Independent review: TOPICS FOR NEUTRAL THIRD PARTY REVIEW IN SUPPORT OF THE REISSUANCE OF THE NATIONAL POLLUTANT DISCHARGE ELIMINATION SYSTEM (NPDES) PERMIT FOR THE CARLSBAD DESALINATION PLANT

Review Panel: Peter Raimondi, Richard Ambrose, Brett Sanders

Date: September 15, 2018

Figure 1: Relationship between Impingement and MGD for 50 “ordinary” events.

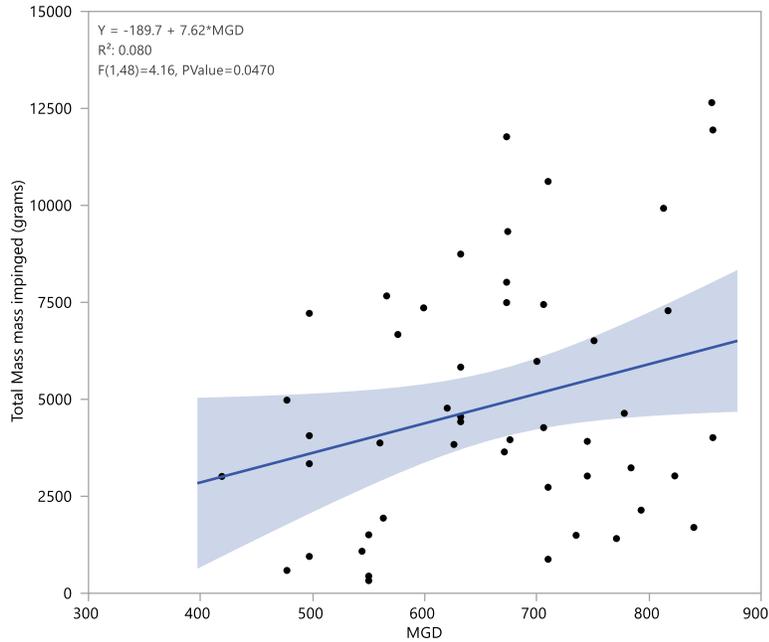
The relationship depicted in figure 1, as expected, shows an increase in impingement as MGD increases. However the relationship is much weaker than expected. This is due to the high level of simple temporal variability in impingement unrelated to flow (e.g. pulses of individuals near the intake structure). Adding the two extraordinarily high impingement events corrupts the relationship entirely (see figure 2 below).

Including all 52 events causes the relationship to shift from positive (figure 1) to negative (figure 2). Note that the relationship is significant in figure 1 ($p = 0.047$) but not in figure 2 ($p=0.2871$). It is clear that the inclusion of all data corrupts the relationship between MGD and impingement. Nordby recognized this and derived an estimate of impingement related to CDP MGD that was based on a hybrid approach. The 50 ordinary events were calibrated by the MGD ratio noted above and the 2 extraordinary events were not. This led to an estimated daily impingement rate of 4.7 kg per day (=10.36 lbs per day). For comparison, calibrating all the data and using the relationship shown in figure 2, the estimate for 304 MGD would have been 14.03 kg per day (at the 50% confidence limit).
